From: Franzone, Steve <Steve.Franzone@fpl.com>
Sent: Monday, August 22, 2016 2:05 PM
To: Comar, Manny
Cc: TurkeyCOL Resource; Wen, Peter; Maher, William; Orthen, Richard; Burski, Raymond
Subject: [External_Sender] PTN 6 & 7 Sea Level Rise
Attachments: L-2011-125 dated 04-06-2011 RAI Ltr 10 eRAI5233 Response to RAI-02.04.05....pdf;
L-2011-474 signed 11-04-2011 Response to NRC RAI Letter No. 036 (eRAI 58....pdf

Re: Florida Power & Light Company
Proposed Turkey Point Units 6 and 7
Docket Nos. 52-040 and 52-041
Response to Request for Additional Information 02.04.05-3, Letter No. 010
(eRAI 5233) Standard Review Plan Section 02.04.05 - Probable Maximum Surge
and Seiche Flooding

NRC RAI Number: 02.04.05-3 (eRAI 5233)

NRC RAI Number: 02.04.05-5 (eRAI 5860)

Figure 1: Monthly Mean Sea Level Trend at Miami Beach with Seasonal Fluctuations Removed.

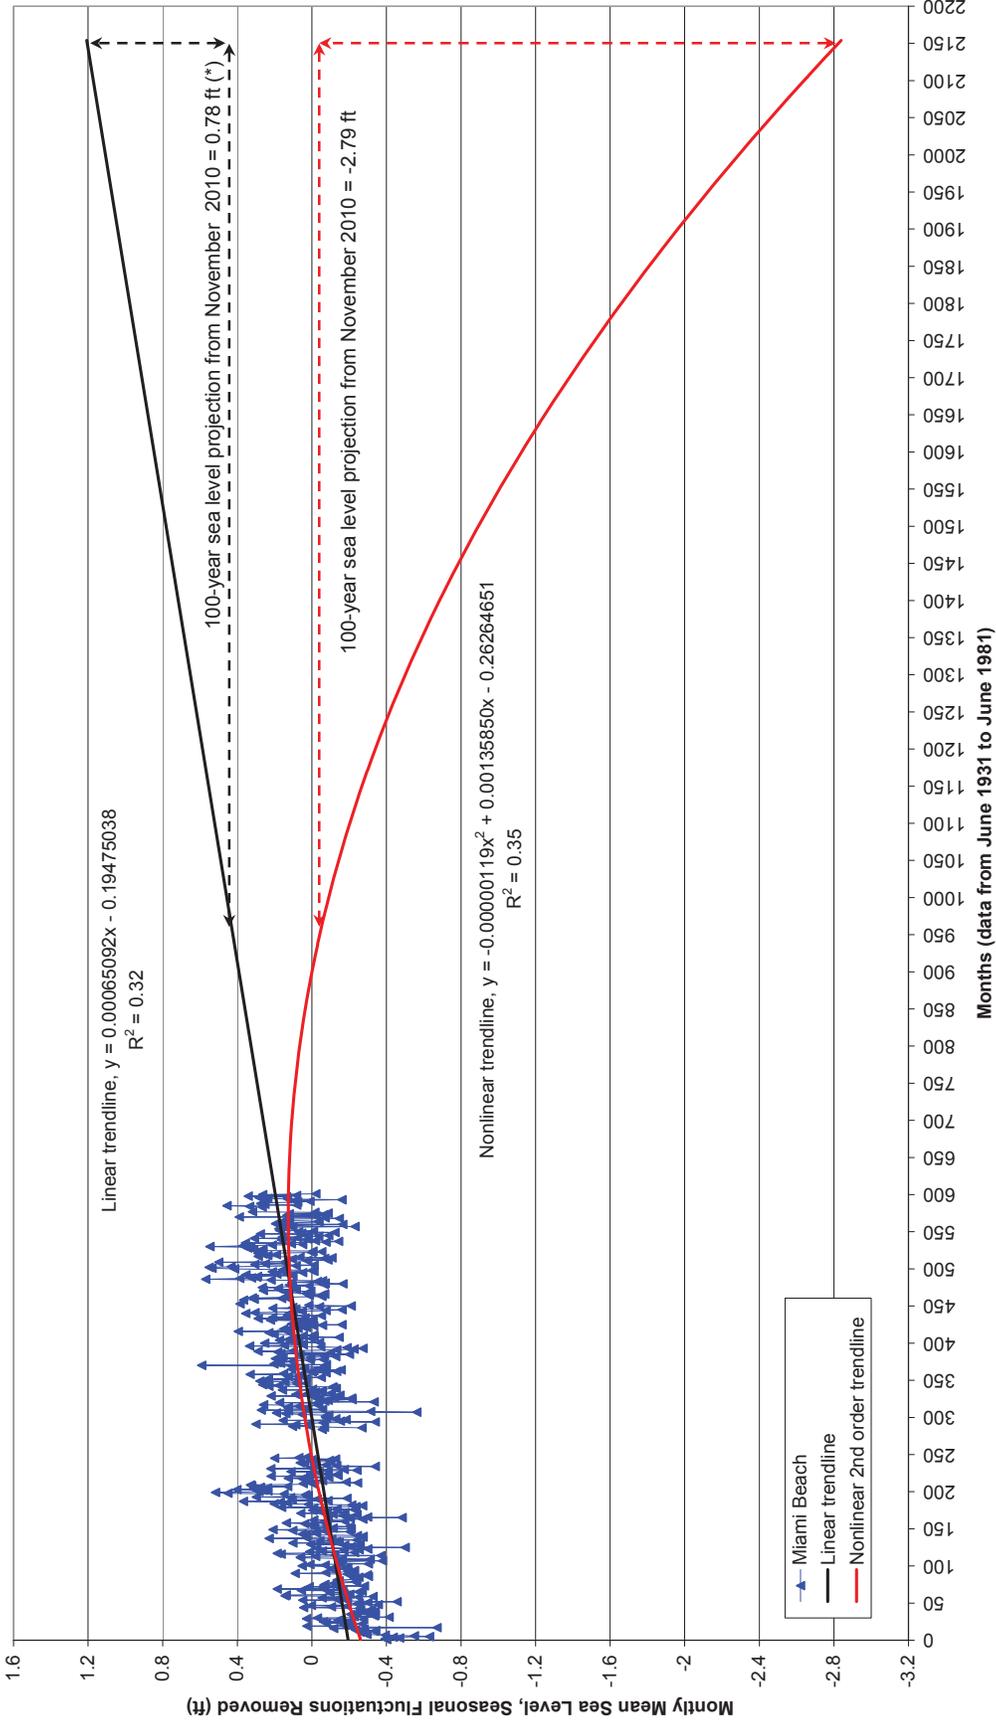
The Applicant's analysis of long-term sea-level rise is based on a linear extrapolation of historical sea-level changes measured at Miami Beach, Florida. Please explain whether a linear extrapolation of sea-level records is conservative compared to a nonlinear model extrapolation approach (e.g., Walton, 2007, etc.). Provide analysis of the effect of a nonlinear model of the future rate of sea-level rise on PMF water levels at Units 6 and 7 resulting from PMH-related storm surge.

As indicated in FSAR Subsection 2.4.5, Revision 2, the long-term sea-level rise for the Turkey Point Units 6 & 7 site is established at 1.0 ft. This rise in sea-level is conservatively estimated based on the rate of 0.78 ft (Figure 1) in 100 years determined for the Miami Beach area by the National Oceanic and Atmospheric Administration (NOAA) (FSAR Subsection 2.4.5, Reference 206). NOAA's analysis is based on a linear trend model using sea-level data at Miami Beach, Florida tide gage station (Station 8723170) (Reference 1). In developing the sea-level rise model, NOAA removed the seasonal fluctuation (long-term average monthly values) from the monthly mean sea level data. Located approximately 27 miles northeast of Turkey Point Units 6 & 7 site, Miami Beach is the closest tide gage station to the site that has a substantially long record of approximately 50 years and is therefore expected to provide a reasonable representation of the sea-level characteristics at the site.

Figure 1: Monthly Mean Sea Level Trend at Key West with Seasonal Fluctuations Removed.

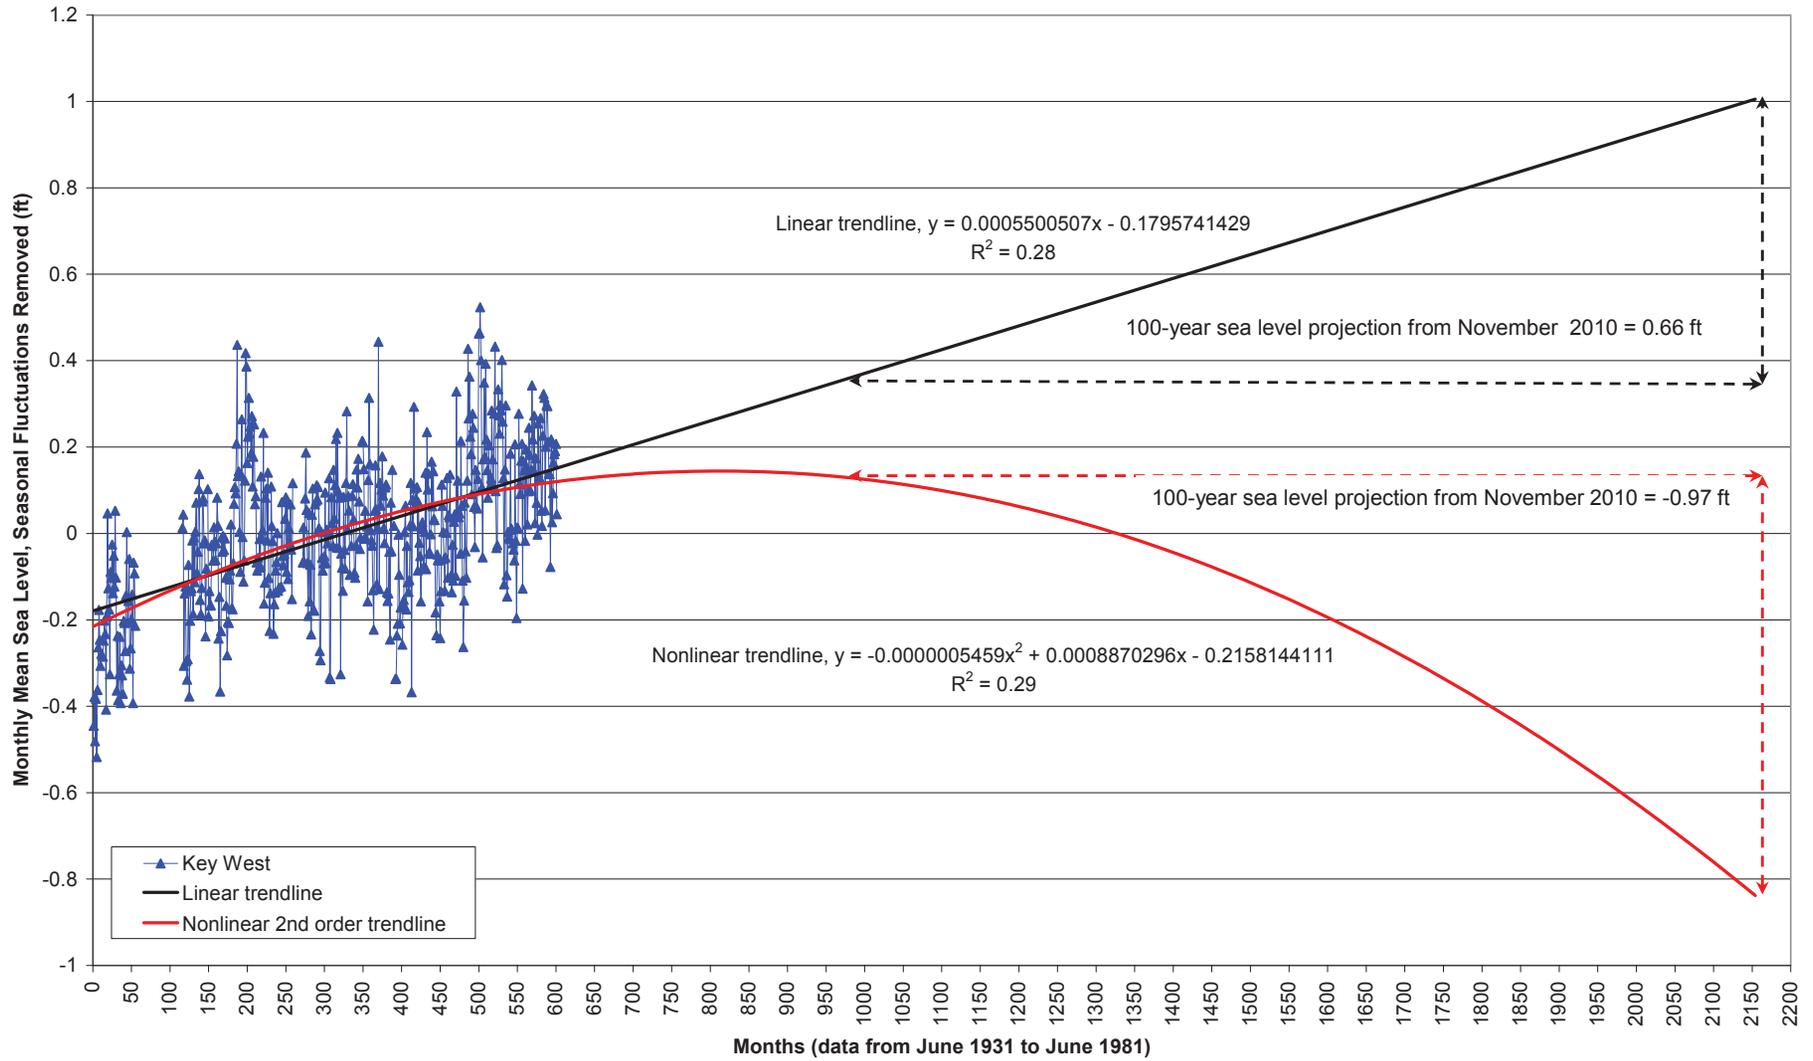
The new analysis that the Miami Beach data set appears to have some shortcomings. The most recent measurements are 20 years old, so the data set may not represent recent trends, and there are gaps in the record from earlier years. A data set exists for Key West that covers a longer period, continuing to the present time, and does not have gaps. R-squared values for both linear and nonlinear trend analyses of the Miami Beach data are much lower than those for trend analyses for Key West data (values of 0.32 to 0.35 for Miami Beach data (versus values of 0.45 and 0.46 for Key West data). Also, the applicant's attempt to fit a second-order trend to the Miami Beach data yields apparently counterintuitive results, in that it predicts a large drop in sea level, which suggests problems with the data set. The applicant's linear regression analysis of the Miami Beach and Key West data sets did, however, find a close correlation between sea level measurements at the two locations (R-squared of 0.85).

Provide reasoning and analysis sufficient to demonstrate that reliance on the Miami Beach sea-level data is a valid and sufficient basis for predicting potential future sea-level rise, when a longer and more recent data set for the region is available from Key West.

As shown in Table 1 and Figure 1, the linear trend model on the historical monthly sea-level data from the Key West station for the period of 1931 to 1981 projects an increase of 0.66 ft in 100 years. The nonlinear model projects a sea-level decline of -0.97 ft in 100 years, which is not considered to be a plausible outcome. Similar trends and projections are exhibited in the Miami Beach data of the same time period. Rather than indicating unsuitability of the Miami Beach data, these trends suggest that the nonlinear trend model is not appropriate for the sea-level data period of 1931 to 1981, as previously indicated in the response to NRC RAI No. 02.04.05-3.
